Inspection Photos

Operator: CHEVRON USA INC - 16700

Location ID: 314707

COGCC

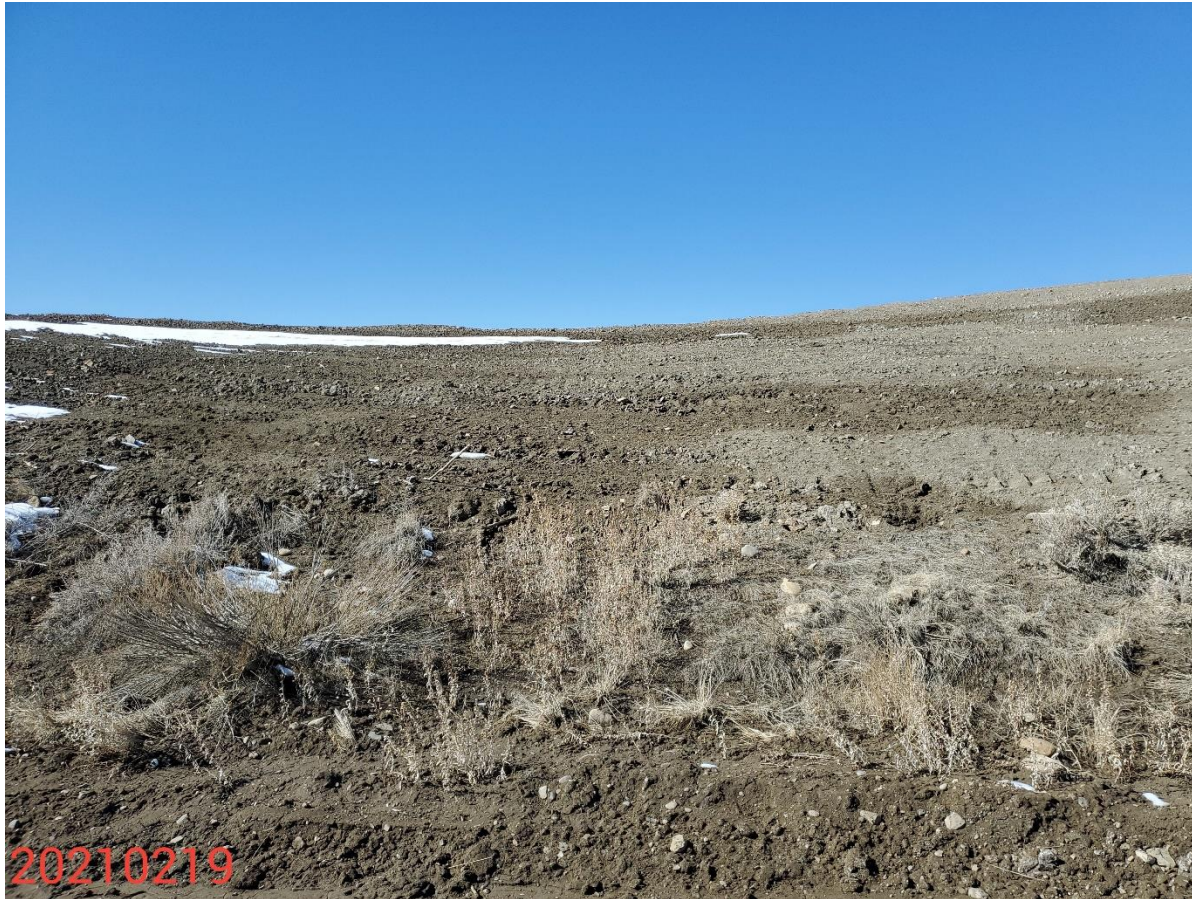
Photo 1: Photo taken from the access road east of the Location, facing southwest. Photo 1-3 provide an overview of the Location/reclamation area from southwest to northwest.

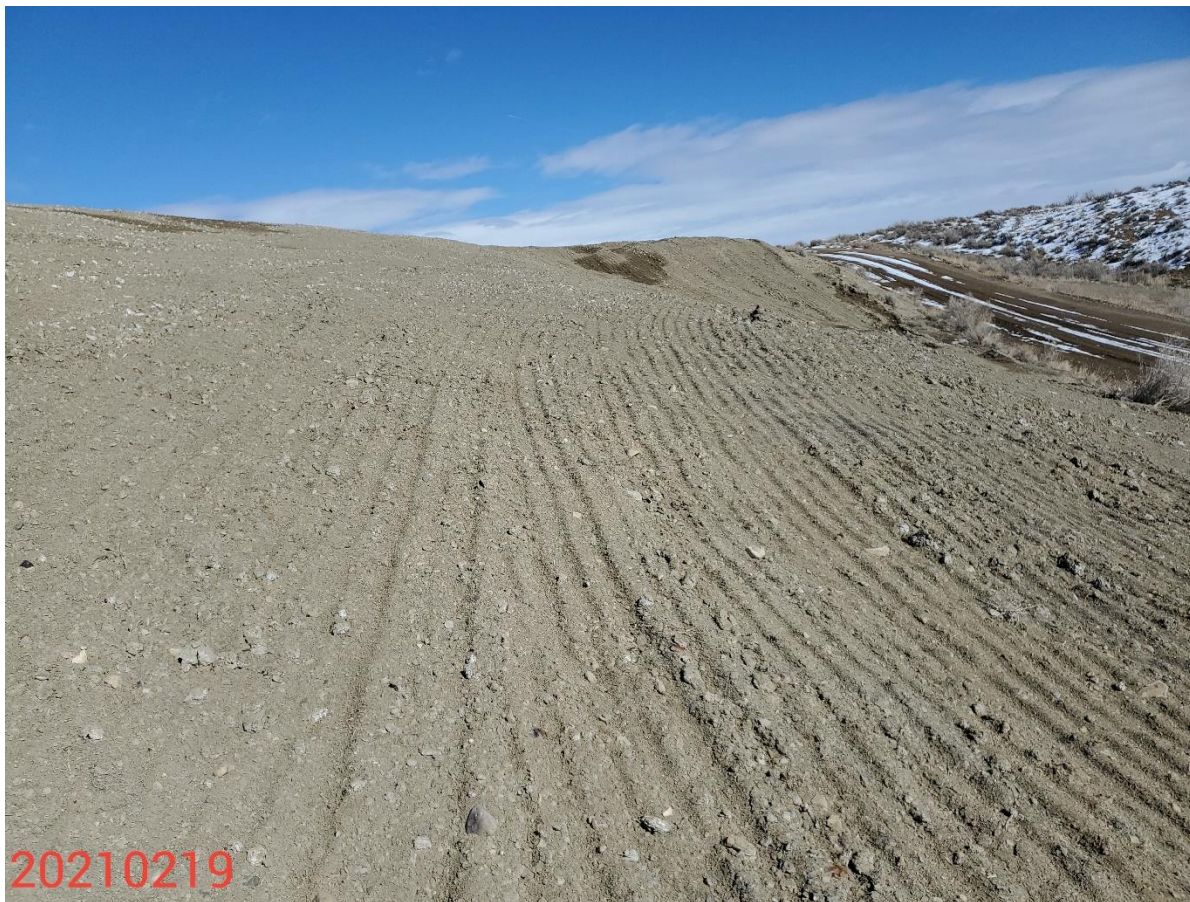
Photo 4: Photo taken from the slopes on the east end of the disturbance area/Location. It was observed that drill seeding appears to have been conducted on the Location. Photo shows an example of slopes observed on the Location where drill seeding, or broadcast seeding is not evident; uniform revegetation activities do not appear to have been conducted. Photo also shows that stormwater and erosion control measures are missing, or insufficient to stabilize the soils and manage runoff from the Location.
